Proposal for a Corrigendum to UN Regulation No. 43

The text reproduced below has been prepared by the expert from Germany to reintroduce

- 2) Annex 20
Paragraphs 2.8.5 and 2.10.3, amend to read:

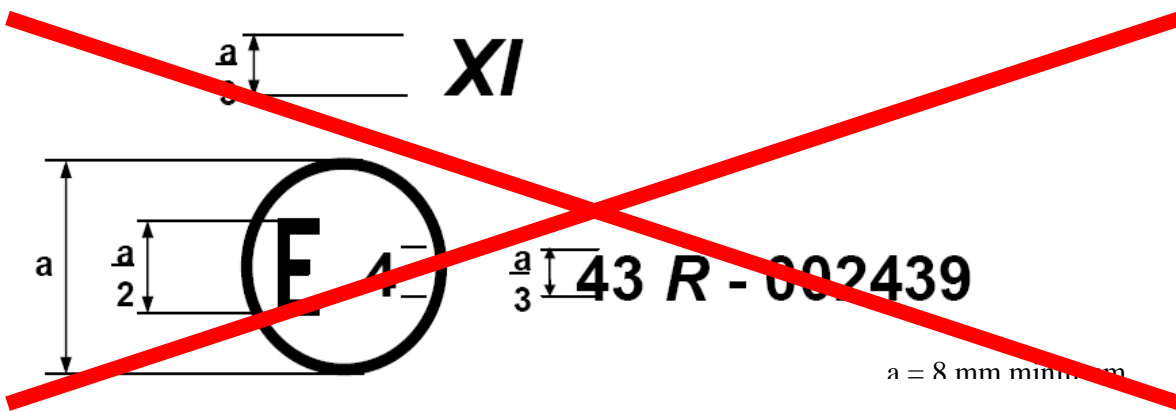
2.8. Rigid plastic panes

2.8.5. Test of resistance to chemicals in accordance with Annex 3, paragraph ~~11.2.1.~~

2.10. Rigid plastic double glazed units

2.10.3. Test of resistance to chemicals in accordance with Annex 3, paragraph ~~11.2.1.~~

2) The paragraphs 2.8.5 and 2.10.3 in Annex 20 were modified according to the requirements of supplement 8 to the 00 series of the regulation. The reference in these paragraphs by error was not transposed as indicated in suppl. 8 (TRANS/WP.29/970).

Glass-plastic panes

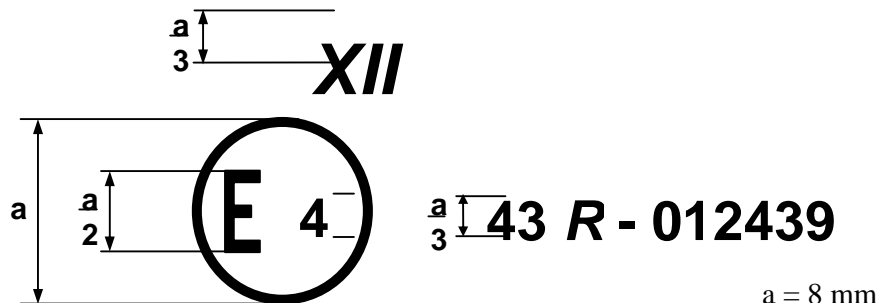
- 3) Annex 2 (Arrangements of approval marks for components)
Approval mark for glass-plastic panes, delete the reference to the approval mark for the 00 series of the regulation:

3) It is proposed to delete the approval mark with the reference to the 00 series of the regulation as this drawing was kept by error in the document (see document ECE/TRANS/WP.29/2011/35).

The above approval mark affixed to glass-plastic pane, shows that the component concerned has been approved in the Netherlands (E4) pursuant to Regulation No. 43 under approval No. 012439. The approval number indicates that the approval was granted in accordance with the requirements of Regulation No. 43, as amended by the 01 series of amendments.
